Re: Hwy. #17 - W.P. 224-59,
Meilleurs Bay - Proposed New
Causeway Fill Material.
District #13.

Meilleurs Bay, D.H.O., Foundation Investigation Report.

Re: Proposed New Causeway on Highway #17,
at Meilleurs Bay, Deep River, Ontario,
District No. 13.

The Proposed New Causeway on Hwy. #17,
at Meilleurs Bay, Deep River, Ontario.
W.P. 98-60 & W.P. 224-59, W.J. 60-F-60.
District No. 13.

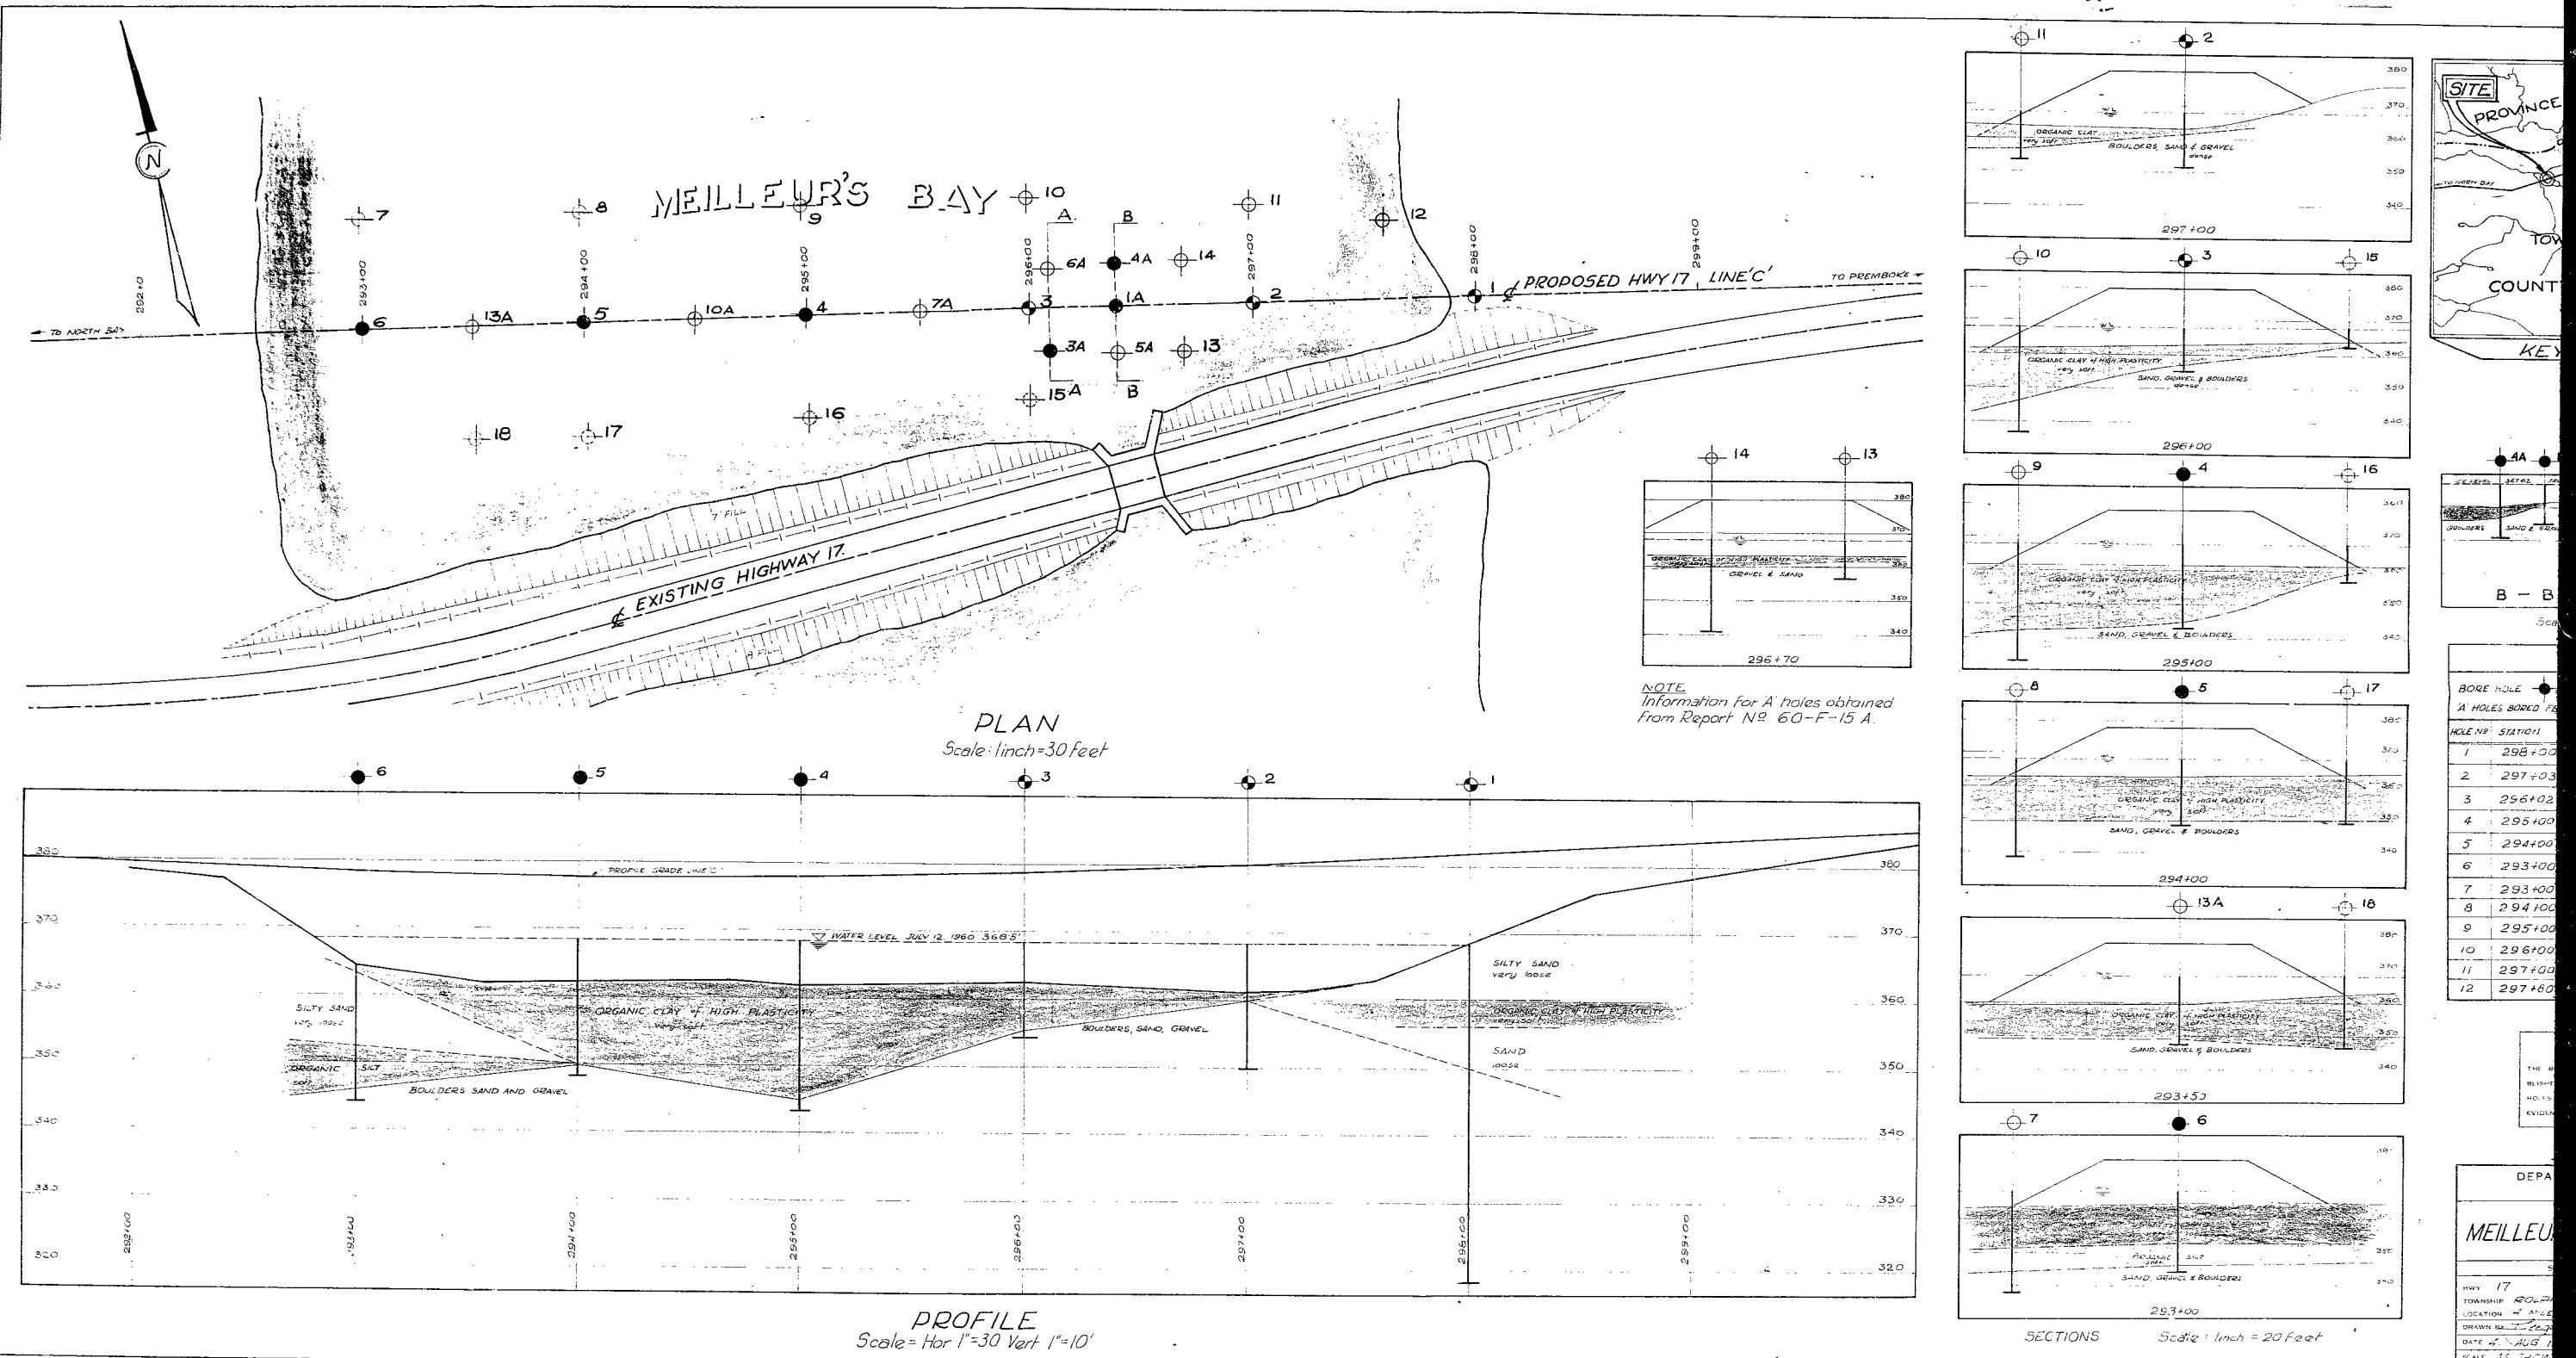
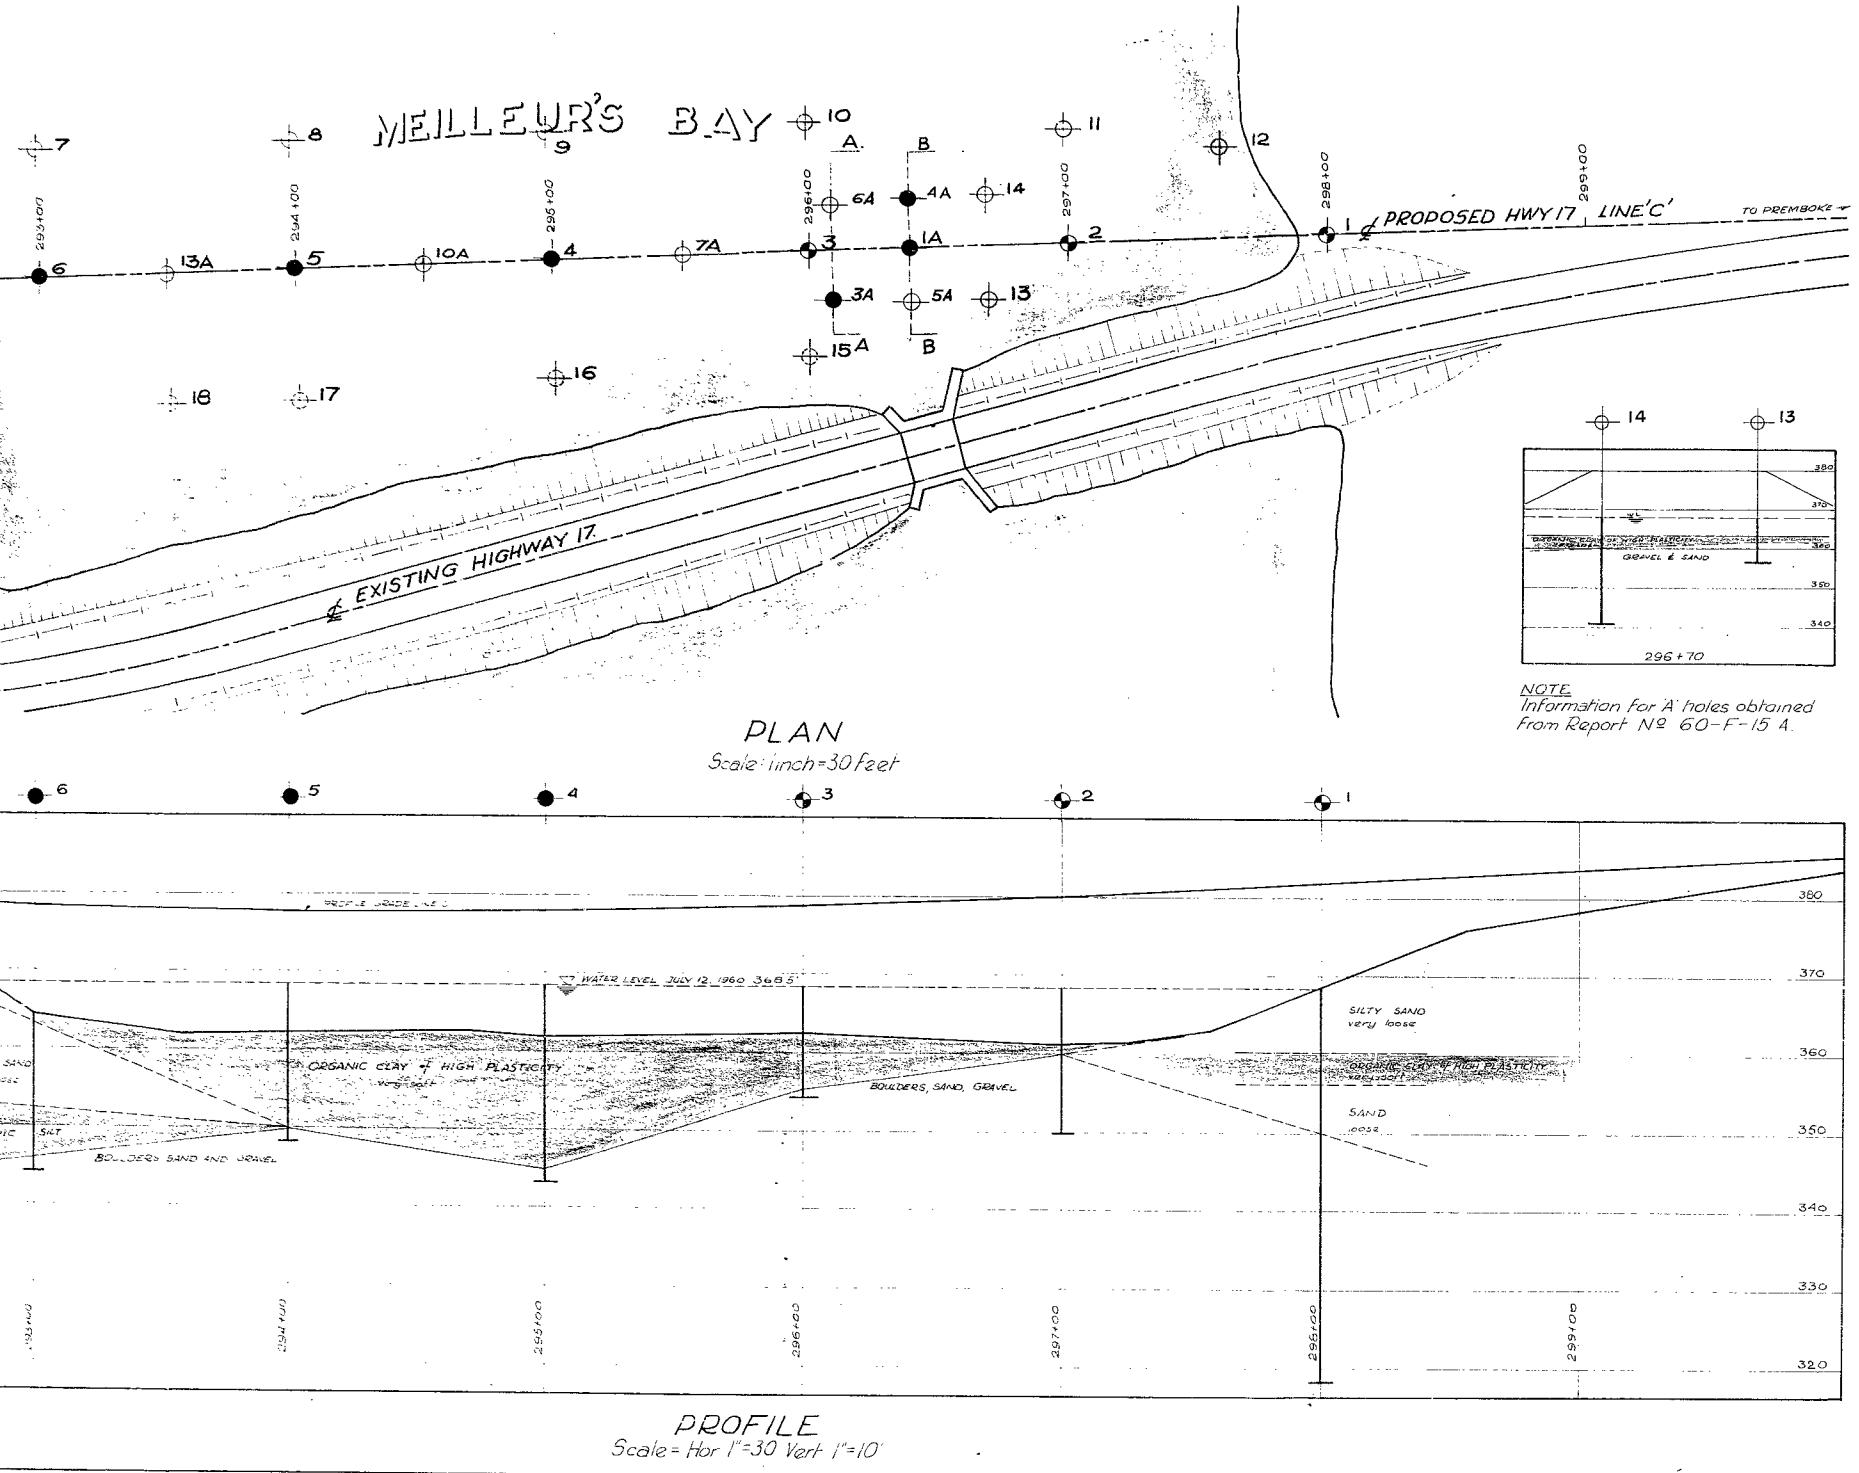
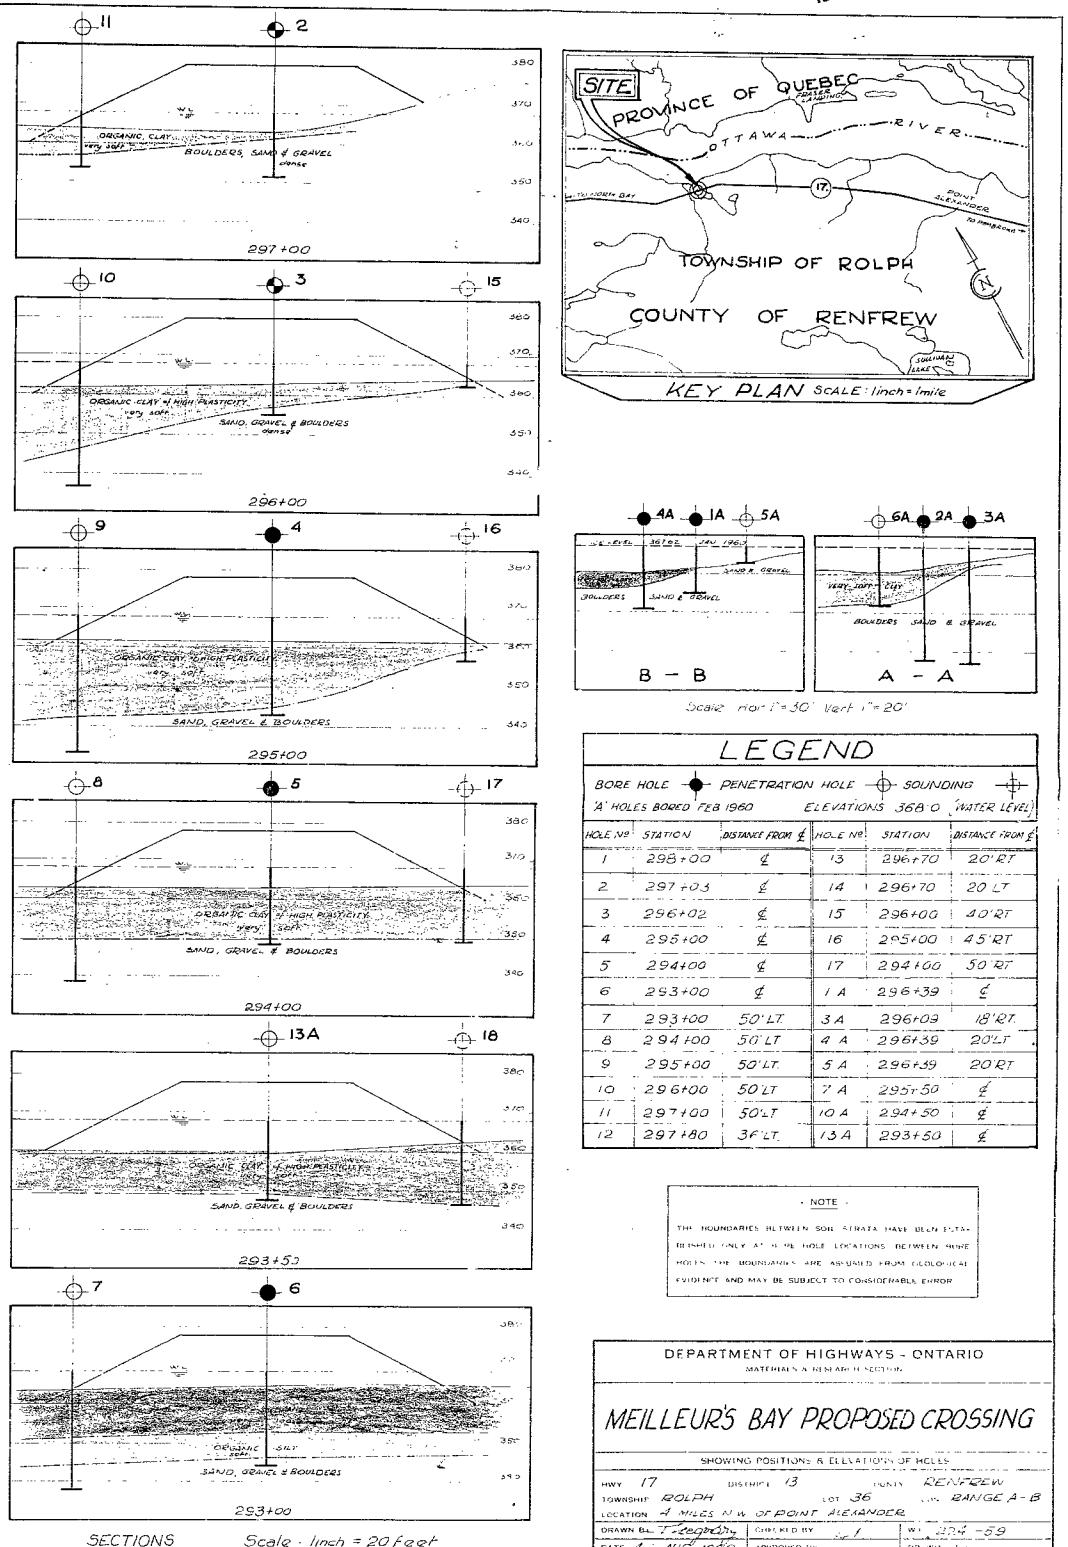
3. Should we not recommend that the fill be started at the South side and constructed to the North, then along the centre line, to ensure displacement of the soft material to the North?

By looking at Drawing No. 60-F-60A of the report, it can be seen that up to about the middle of the bay, from West to East, the hard sand-gravel bottom is level; therefore, the displacement in both directions will be equally easy. Farther to the East, the hard bottom slopes in the northern direction. The material will always displace in the direction of lesser resistance, and it is our opinion that in this location, it will displace towards the South, because it will meet, here, less resistance in spite of the sloping hard bottom.

The hard bottom underlying the eastern part of the causeway does slope toward the North. The quantities of the clay to be displaced South of centre line are comparatively small, and it is our opinion that advancing the fill at an angle to force displacement to the North of centre line would give rise to an undesirable large berm of remoulded material on the North side of the embankment. The development of this berm would serve only to make displacement more difficult, and could result in material being trapped, or not completely displaced under the North section of the roadway. The principle to be followed in displacement of soft foundation material by loading, is to cause the disturbed material to move the least distance possible. The procedure of advancing the fill with a centre V-type front is based upon this principle.
